TOWN OF ACTON
Building Department

To: Board of Selectmen **Date:** January 9, 2003
From: Garry A. Rhodes, Building Commissioner 
Subject: Restaurant Special Permit #11/04/02-385/Common Victuller's (Hunter)
Starbucks Coffee, 411 Mass Ave.

RE: Starbucks Revised filing

Detail Sheet
411 Massachusetts Ave.
Acton MA

DRYWELL DETAIL
N.T.S.

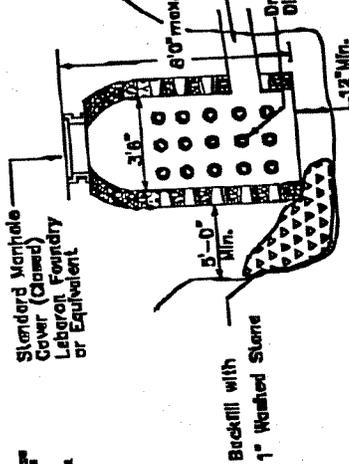
Good morning- I am faxing the backup drainage computations for the site plans
 You should have original drawings Today.
 I did make the change to a drywell as you requested to pick up the incremental change in
 the drainage runoff.
 We have also made an effort to address the comments presented in the original filing

- 4) As request by engineering we have called for a catchbasin w/ 4' sump & hood to location, Drywell

Storage available by drywell and stone at 30% porosity exceeds 57 cu

Provides adequate storage and recharge.
